# City of Columbus

## Standard Drawings

Summary of 2007 Revisions – 12 Sheets

## Summary of 2007 Revisions

STD DWG  
**2319**  
REV: 01/01/07  
SHT 4 OF 12

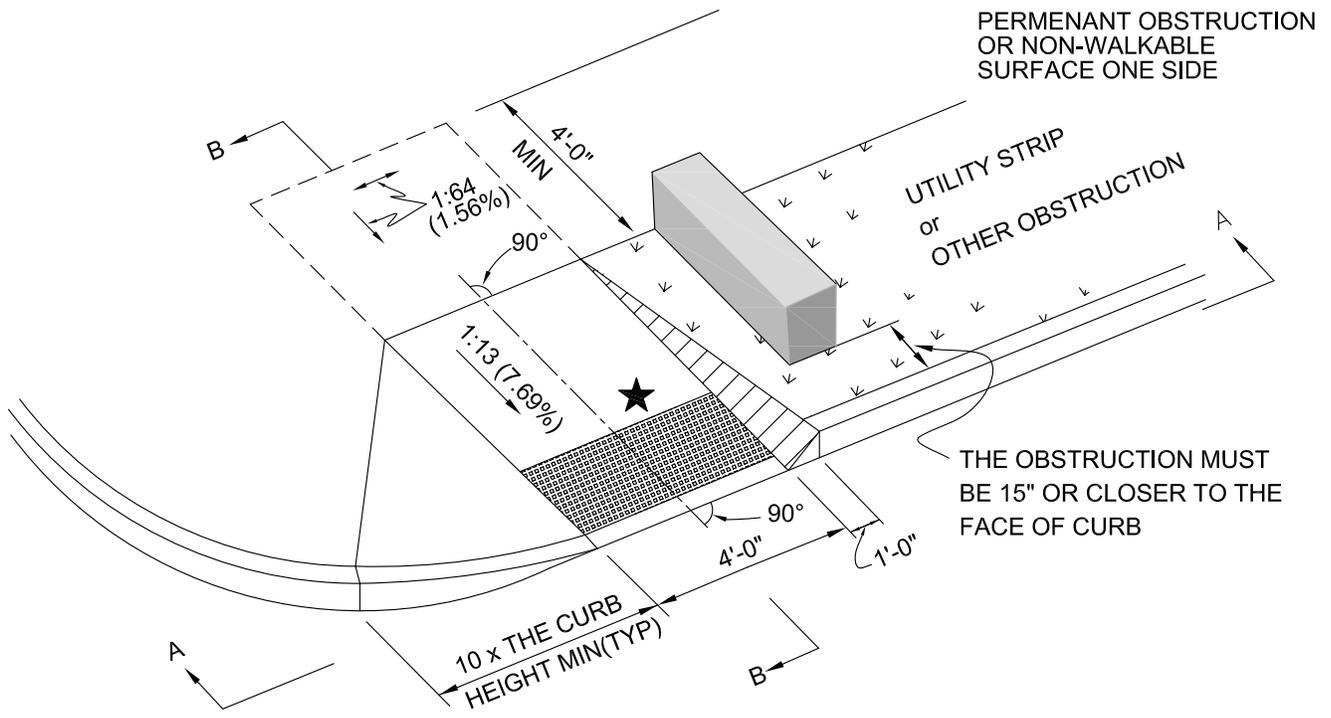
Sheet four – FORMERLY SHEET 5 - Type C curb ramps - This sheet shall become the new sheet 4 of 12. The same changes in the section profile detail from sheet 3 will also apply to the section detail of this sheet. In the isometric view dashed the sidewalk landing above the ramp.

## CURB RAMP TYPE G ALLEYS & DRIVEWAYS

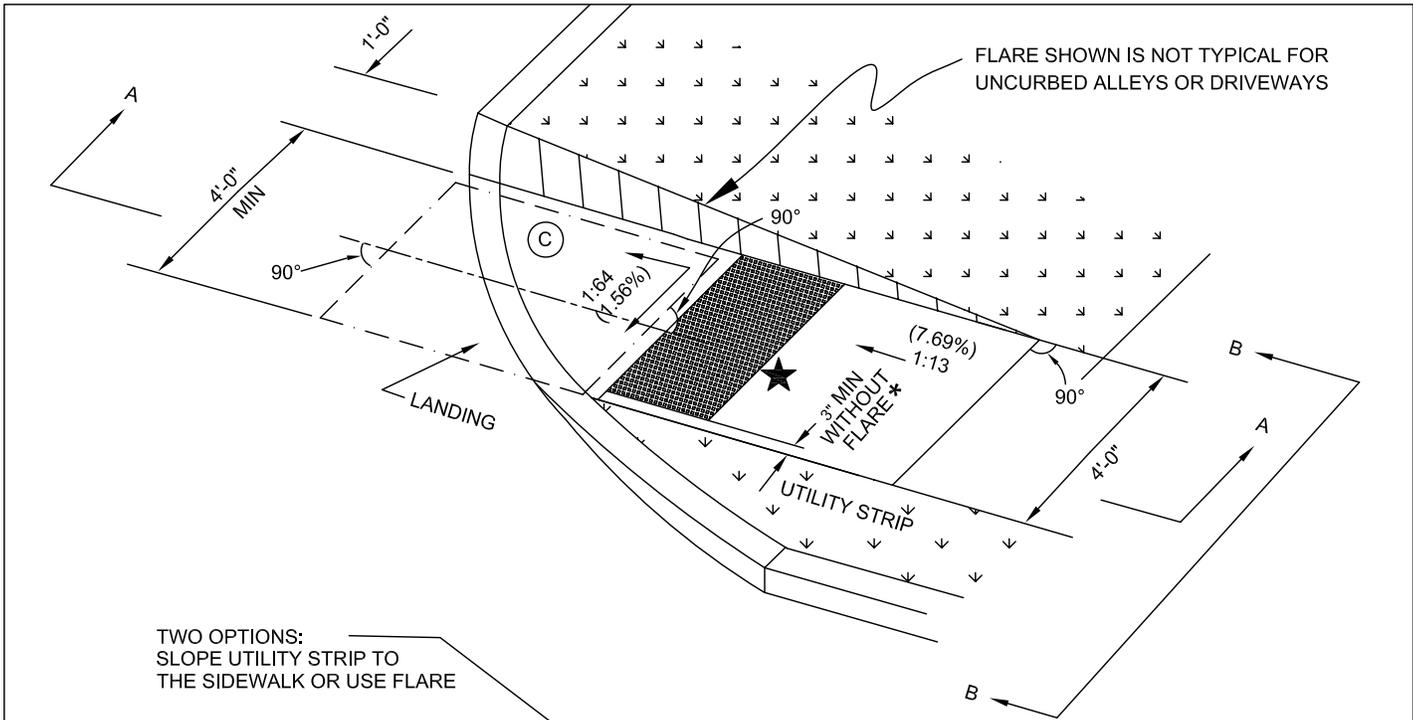
Sheet six – FORMERLY SHEET 8 – Type G curb ramps – The new sheet 6 of 12. In the isometric view deleted the 2' dimension and lines. Extended the 1-foot flare line to the top of the ramp panel. Changed the curb note at the top of the sheet to read, "Flare shown is not typical for uncurbed alleys or driveways". Deleted the B-B section lines and arrows. Deleted the entire section B-B detail from the sheet. In section A-A added an arrow line and the words "expansion material". Deleted note E from the bottom of the sheet.

# CURB RAMP TYPE H ALLEYS & DRIVEWAYS

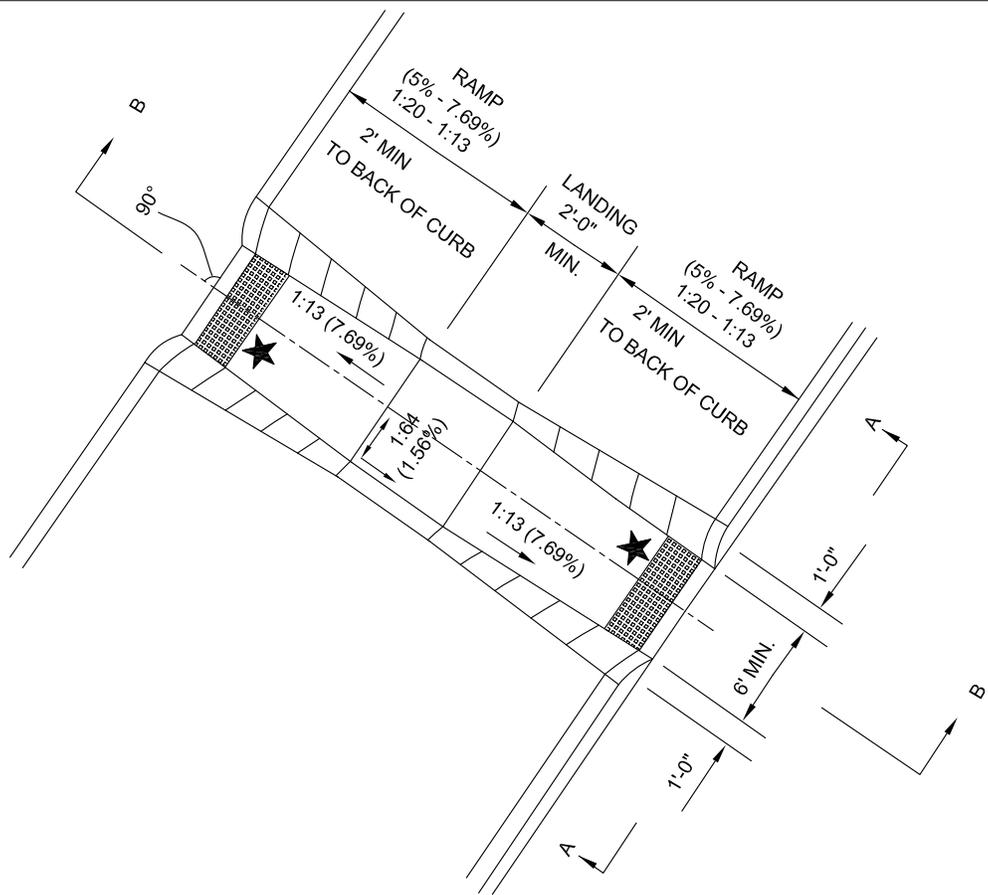
Sheet seven – FORMERLY SHEET 9 - Type H curb ramps – The new sheet 7 of 12. In the isometric view deleted the 2' dimension and lines. Moved the A-A section cut lines as shown. Extended the flare line to the top of the ramp panel. Labeled a minimum of 3" between the detectable warning and the ramp edge when no flare is used and installed an asterisk. At the bottom of the sheet added an asterisk note that reads "This requirement is for embedded (non-surface applied) detectable warnings only". Deleted note E. In section B-B added, "flare" under the "1'-0". On the left side of the ramp added "Two Options: Either slope the utility strip to the ramp or use a flare". In a dashed line illustrated both options. In section A-A added an arrow line and "expansion material".

# CURB RAMP TYPE L MEDIAN RAMP WITH LANDING

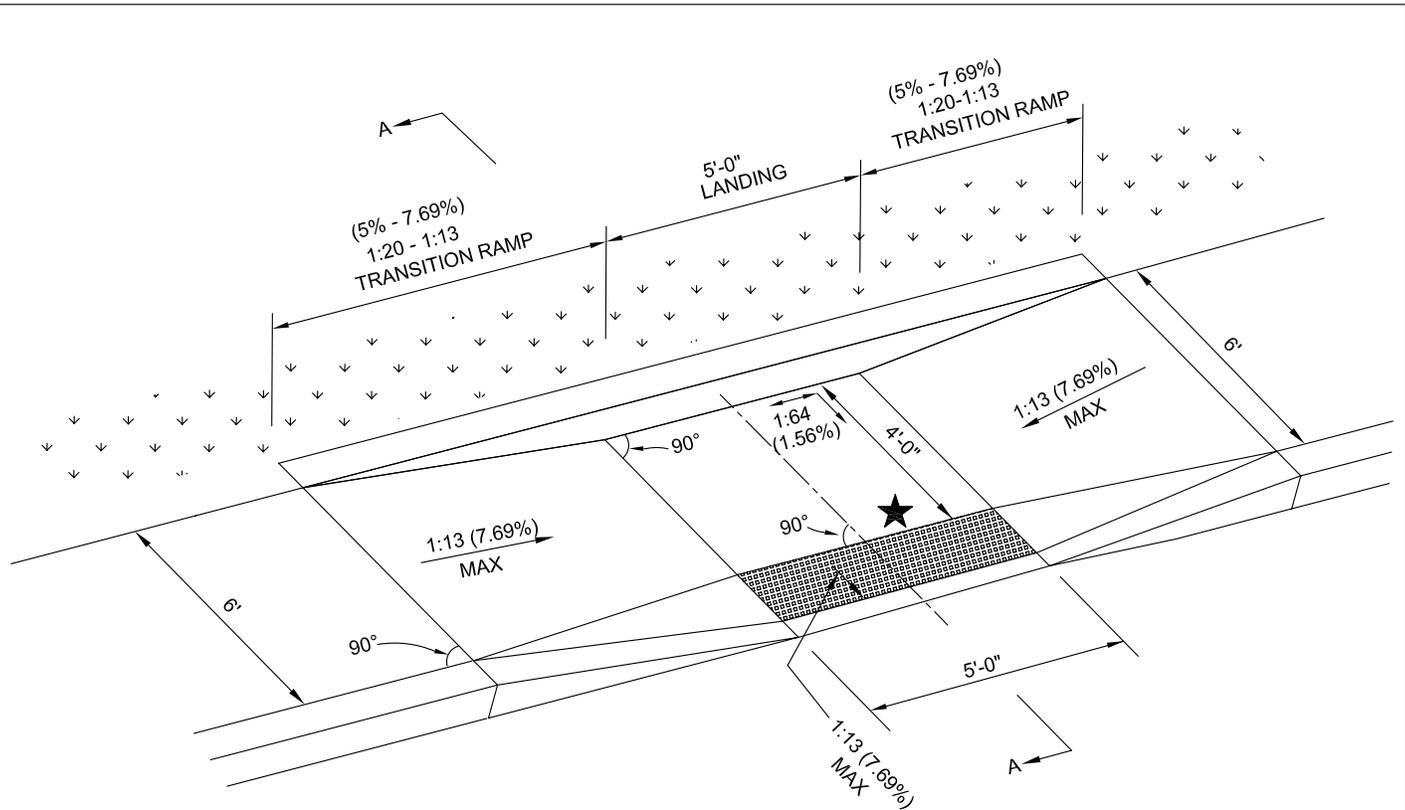
Sheet eight – FORMERLY SHEET 11 – Type L curb ramps for medians – The new sheet 8 of 12. In the top view moved the A-A section lines. Changed the minimum opening width to 6'. Changed the minimum length for the ramps and landing to be 2-foot. Labeled the 2-foot ramp length dimension to be from the back of curb. In section detail B-B deleted the dimension for the upper landing. Gave a minimum length to the lower landings. Deleted the "1/2" preformed joint filler" label and replaced with "Expansion Material".

# CURB RAMP TYPE P-1 PERPENDICULAR & PARALLEL

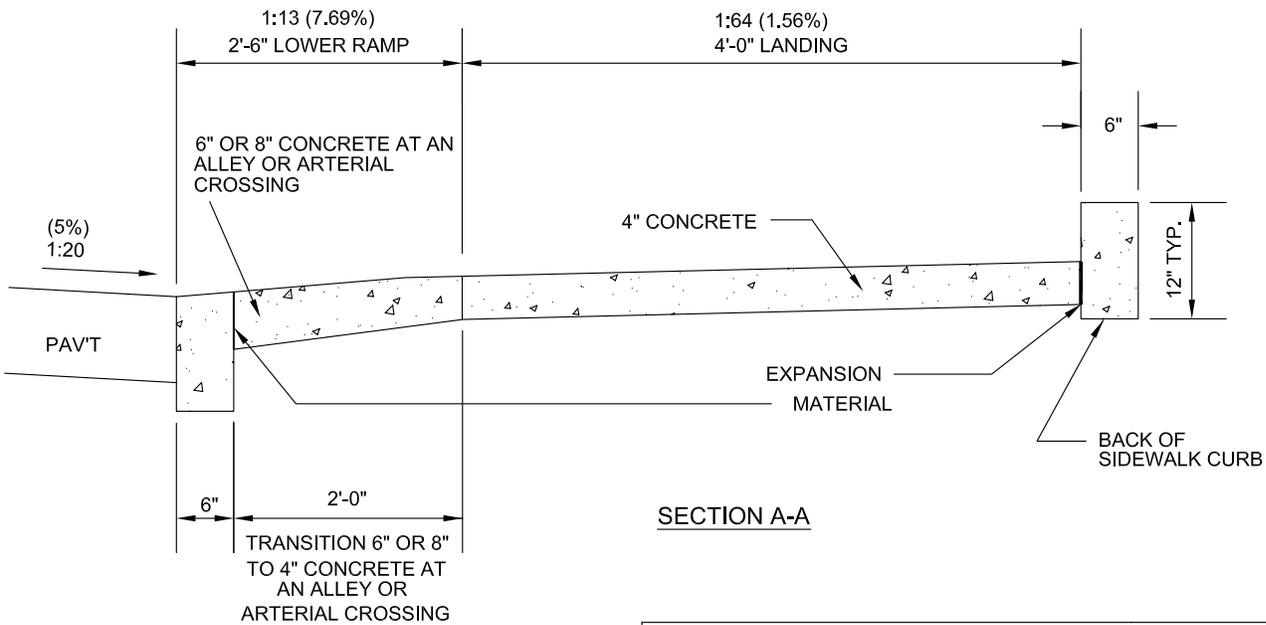
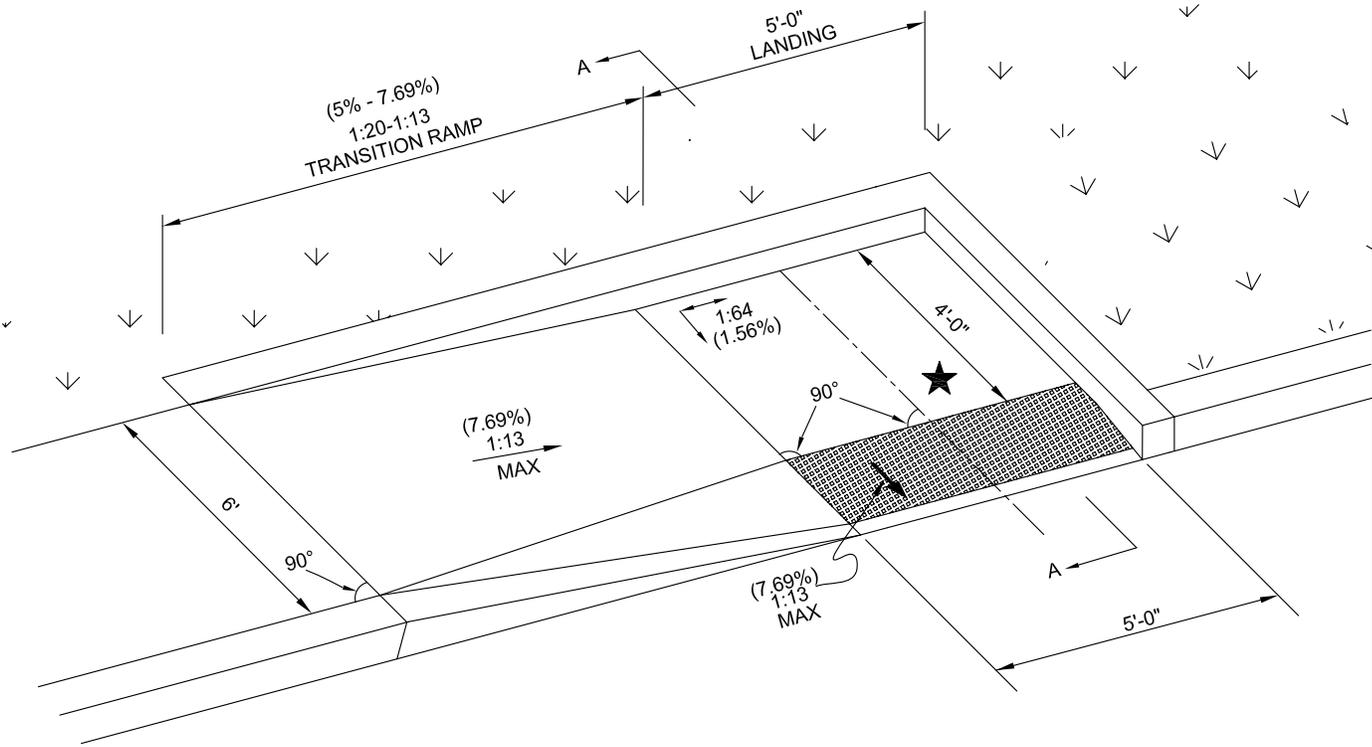
Sheet nine – FORMERLY SHEET 12 - Type P-1 curb ramps – The new sheet 9 of 12. Corrected the flares and detectable warning in the isometric. Relocated the cut lines. Deleted the sidewalk transition panels. Changed the ramp width at the street from 4-feet to 5-feet. In section A-A flipped the detail to match the cut lines. Labeled the back of sidewalk curb. Deleted the 4" as the concrete thickness at the street and added "or 8" at an alley or arterial crossing" to the two concrete thickness labels. Deleted 1/2" from the expansion material and ran an arrow to show expansion material between the ramp and back of the street curb.

## CURB RAMP TYPE P-2 PERPENDICULAR & PARALLEL (ONE DIRECTION)

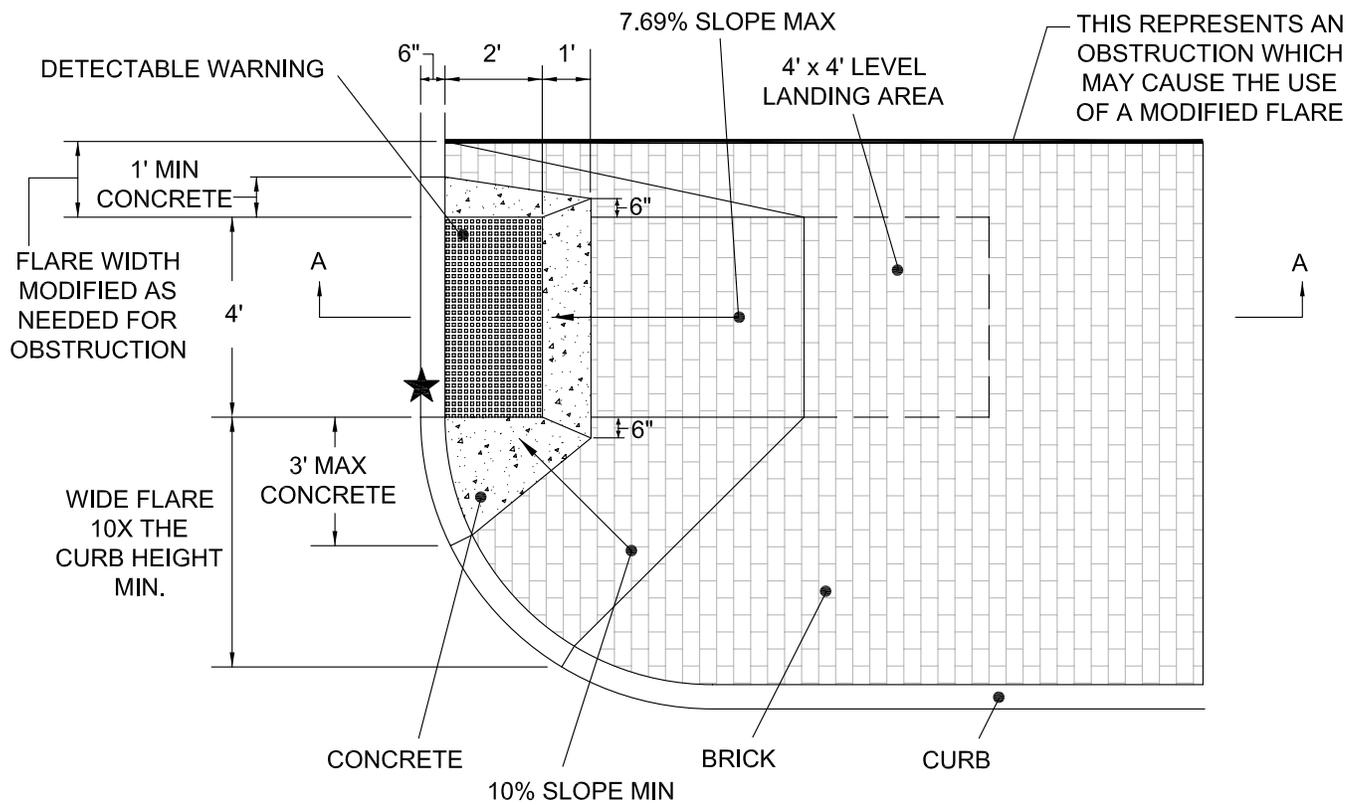
Sheet ten – FORMERLY SHEET 13 - Type P-2 curb ramps – The new sheet 10 of 12. To section detail A-A made the same changes as for sheet 9 of this standard drawing. Corrected the flare in the isometric view. Moved the cut line. Deleted the dimension lines from the utility strip. Deleted the sidewalk transition panel.
